Agenda Item # 18

SUB-002950-2024

Milton Tee Subdivision, Resubdivision of Lot 11

- Subdivision approval to create four (4) legal lots of record from one (1) legal lot of record.

DETAIL SITE PLAN

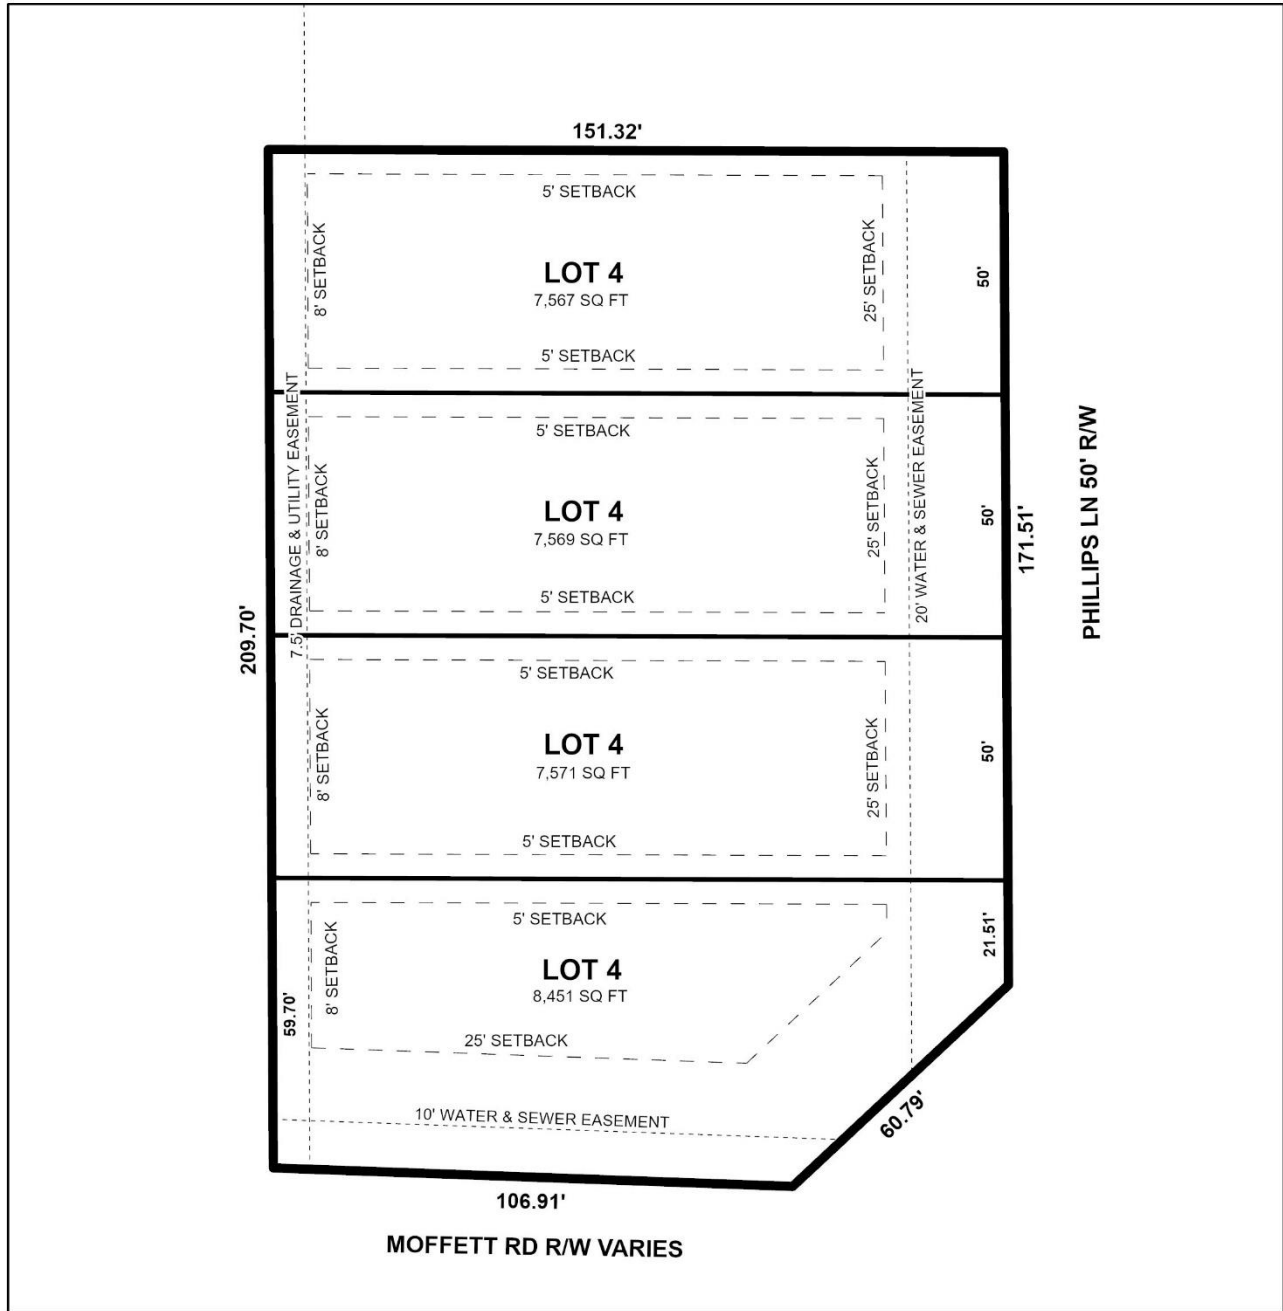
Proposed Lot 1 has frontage along Moffett Road, an ALDOT-maintained, Principal Arterial road requiring a 100-foot wide right-of-way at this location; and Phillips Lane, a minor street with curb and gutter requiring a 50-foot wide right-of-way. Sufficient right-of-way is illustrated along Phillips Lane, but a note on the plat states the right-of-way along Moffett Road varies. While that may be true, GIS maps indicate there is sufficient right-of-way at this location. As such, the plat should be revised to label the 100-foot wide right-of-way along Moffett Road.

The lots, as proposed, exceed the minimum size requirements for lots served by public water and sanitary sewer in an R-1, Single-Family Residential Suburban District, and are labeled in both square feet and acres on the preliminary plat, as required by Section 5.A.2(e)(4) of the Subdivision Regulations. This information should be retained on the Final Plat; or provision of a table on the Final Plat with the same information will suffice.

None of the lots meet the minimum 60-foot width requirement of Section 6.C.2(b)(2) for residential lots located within the suburban sub-district. As such, a waiver of Section 6.C.2(b)(2) of the Subdivision Regulations will be required for approval of the request.

A 25-foot front yard setback is illustrated along Phillips Lane and Moffett Road, in compliance with Article 2 Section 64-2-5.E. of the Unified Development Code for lots zoned R-1 in the Suburban sub-district. If approved, this information should be retained on the Final Plat.

Five (5)-foot side yard setbacks and an eight (8)-foot rear yard setback are illustrated along side and rear property lines, which is not required by the Subdivision Regulations. As such, removal of the side and rear setbacks from the Final Plat should be required.

1. Revision of the plat to label the 100-foot right-of-way along Moffett Road at this location;
2. Retention of the lot sizes in both square feet and acres, or provision of a table on the Final Plat providing the same information;
3. Retention of the 25-foot front yard setback along Phillips Lane and Moffett Road;
4. Removal of the side and rear yard setback lines from the Final Plat;
5. Compliance with all Engineering comments noted in this staff report;
6. Placement of a note on the Final Plat stating all Traffic Engineering comments noted in this staff report;
7. Compliance with all Urban Forestry comments noted in this staff report; and,
8. Compliance with all Fire Department comments noted in this staff report.
